**Marion County
Board of County Commissioners**

**PLANNING & ZONING SECTION
STAFF REPORT**

Hearing Dates	P&ZC Date: 11/24/2025	BCC Date: 12/16/25
Case Number	251209ZP	
CDP-AR	33384	
Type of Case	Rezoning: from General Agriculture (A-1) to Planned Unit Development (PUD)	
Owner	Linda Capozzoli	
Applicant/Agent(s)	Mastroserio Engineering, Inc.	
Street Address / Site Location	7317 SW 80TH ST	
Parcel Number	35460-039-00	
Property Size	±19.75 acres	
Future Land Use	Low Residential (LR)	
Zoning Classification	General Agriculture (A-1)	
Overlay Zone/Scenic Area	Urban Growth Boundary (UGB), Secondary Springs Protection Overlay Zone (SSPOZ)	
Staff Recommendation	APPROVAL WITH CONDITIONS	
P&ZC Recommendation	TBD	
Project Planner	Erik Kramer, Planner	
Historic/Related Case(s)	Concurrent 25-S15 – Small-scale comprehensive plan map amendment from Low Residential (LR) to Medium Residential (MR)

Figure 11
Front Setback Variation Typicals

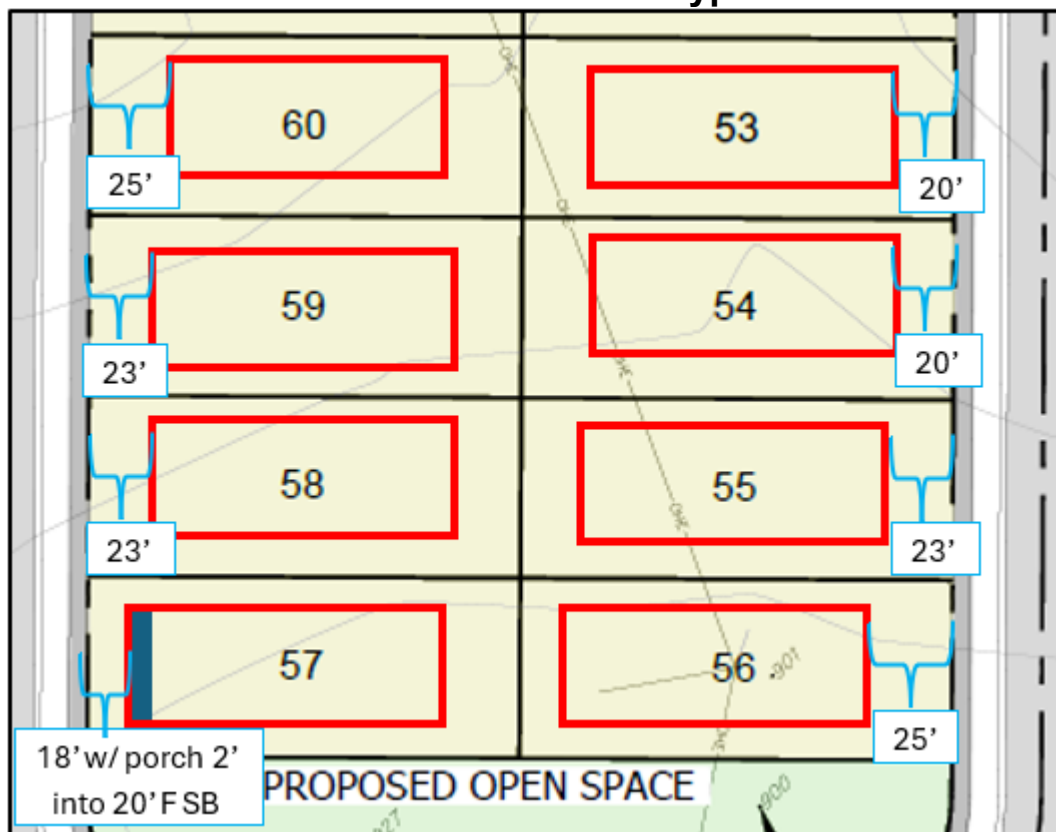
Analysis: Staff find the PUD proposes its own setbacks and height limitations on the PUD plan sheet. Table 3 of this report shows the proposed setbacks and height limits. The proposed minimum lot size and minimum side and rear setbacks are lower than typical Single-Family Dwelling (R-1) zoning for detached single-family development and lower than the A-1 zoning present in the surrounding. The proposed single-family uses are compatible with existing uses in the area; however, the proposed lot sizes and minimum yard sizes differ from the character of the surrounding area. The existing character is small farms and residential estates on larger lots to the north, east, and south with mature tree canopies. To the west is Hibiscus Park Unit 1 and 2, which were platted with smaller lots; however, the existing parcel configurations are large lots with mature vegetation on most of the lots. To match and enhance the character of the area, staff recommends the following conditions pertaining to shade trees and front setback variation (setback typical example shown in Figure 11):

- *Each residential lot shall provide a minimum of two (2) shade trees. The shade trees shall be a minimum of four (4) inch caliper at the time of planting.*
 - *On the side of the street where internal sidewalks are provided, every other lot must locate one (1) of the required shade trees within the front yard and within ten (10) feet of the sidewalk edge.*
- *With any group of three (3) consecutive dwelling units along the same street frontage, the front building line of each dwelling shall vary by at least two (2) feet and no more than five (5) feet from the adjacent unit. No more than two (2) consecutive dwellings may have the same front setback. The pattern of setback variation shall be shown on the improvement plan during development review and maintained through building permit review.*

8. With any group of three (3) consecutive dwelling units along the same street frontage, the front building line of each dwelling shall vary by at least two (2) feet and no more than five (5) feet from the adjacent unit. No more than two (2) consecutive dwellings may have the same front setback. The pattern of setback variation shall be shown on the improvement plan during development review and maintained through building permit review.
